SICHERHEITSMITTEILUNG für AAD

Nummer: 05/2016

**SERVICE
BULLETIN**

1. Issue Date : **September 30, 2016**
2. Bulletin number : **02/09/2016**
3. Subject : **m2 AAD Cutter Replacement**
4. Status : **Mandatory**
5. Identification : **Identification of affected m2 AAD cutters**

Fig.1

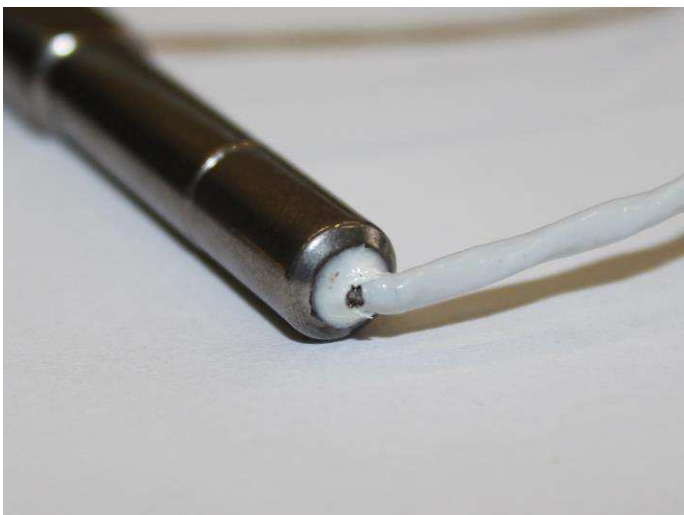
The cutter cable insulation has cracked on some MarS m2 AAD cutters as shown in Fig. 1. Investigation by the manufacturer has shown that this is caused by the method used to close and seal the cutter body. The cracking only affects the insulation, and the function of the device is unaffected. However, as a precaution, all cutters that are affected by this bulletin must be replaced.

a. If a problem exists with the cutter this will be detected by the control unit and displayed as an error No.2. In this case, the cutter must be replaced immediately.

b. If no error is detected, then the AAD may remain in use until the next repack cycle. During the next regular repack the cutter must be inspected and replaced if it is affected by this bulletin.
